# *Nomad* SERVICE BULLETIN

## FUEL-QUANTITY TRANSMITTERS-CORROSION INSPECTION AND REWORK (POST MOD N3 AND OPTION G99, G99F AND G99M)

#### Reason for Revision 2

Figure 1

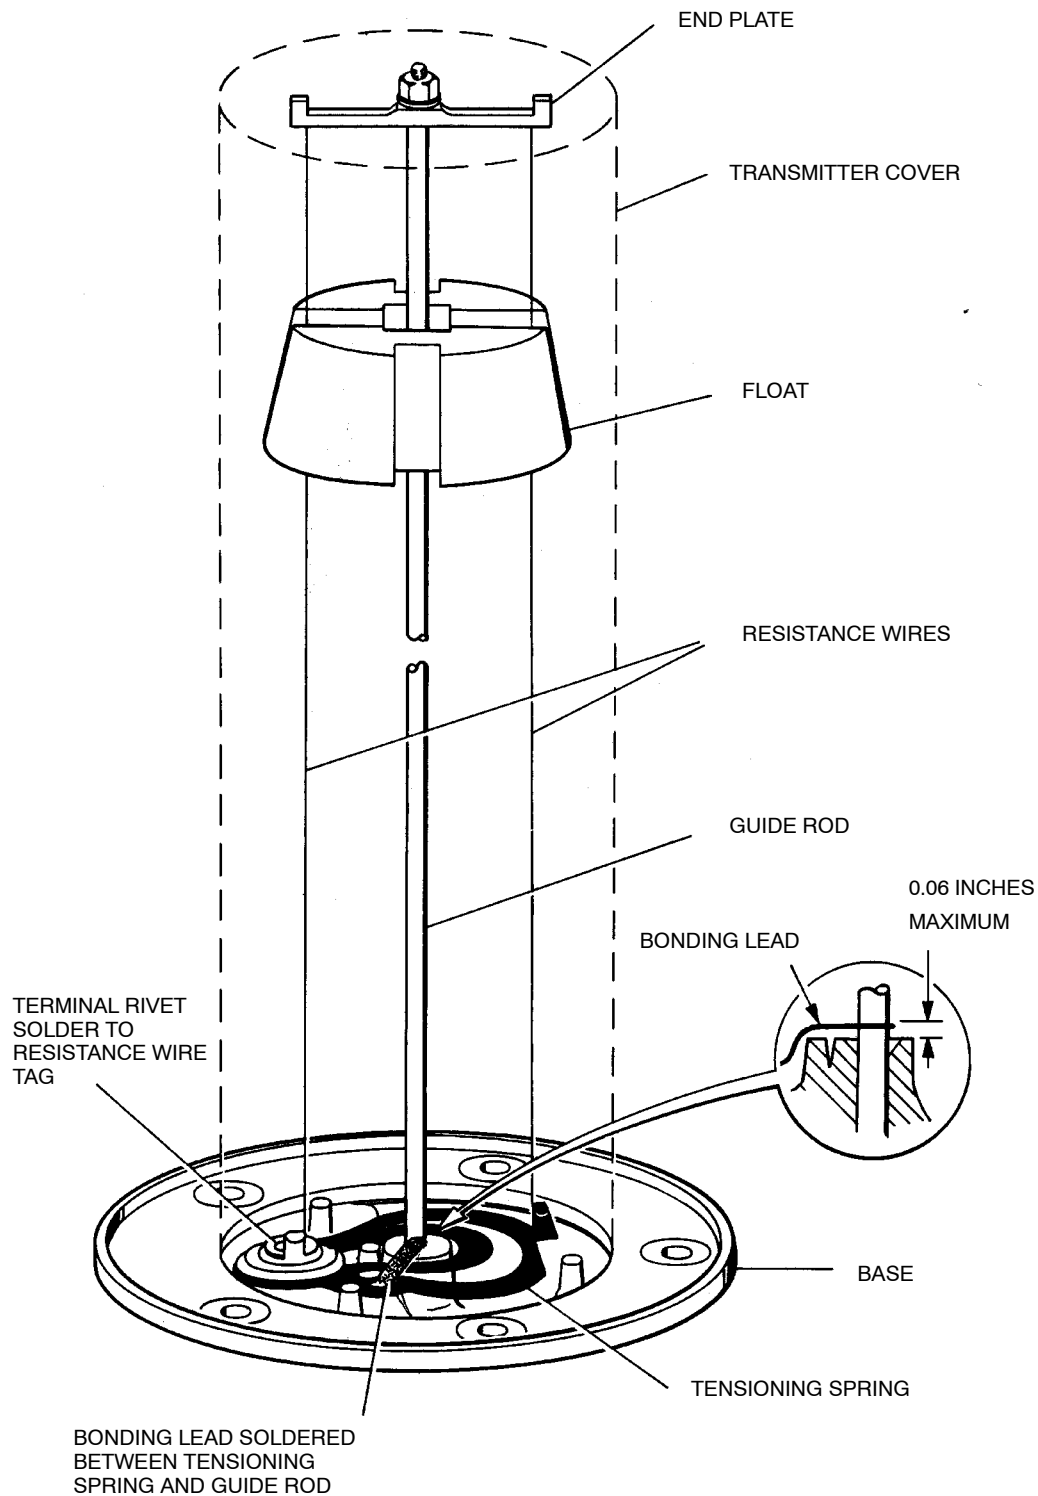
- (7) Solder a piece of braided copper bonding lead, one centimetre in length, between the resistance wire tensioning spring and the float guide rod. Take care to keep the bonding lead as low as possible so that the float range of travel is not reduced. Also solder the resistance wire tag to the terminal rivet (Ref Figure 1).
